Notice of Allowability

10/823,822

LIAW, JHON JHY

Fig. 1A
(PRIOR ART)

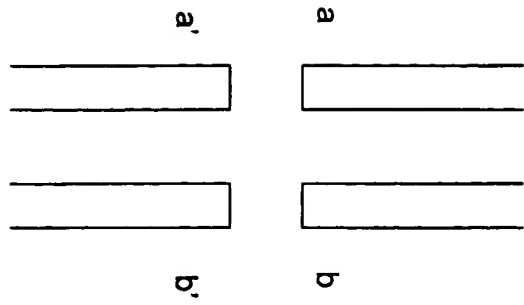
The following changes to the drawings have been approved by the examiner and agreed upon by applicant: Figures 1A, 1B, and 1C were labeled --(PRIOR ART)--. In order to avoid abandonment of the application, applicant must make these above agreed upon drawing changes.
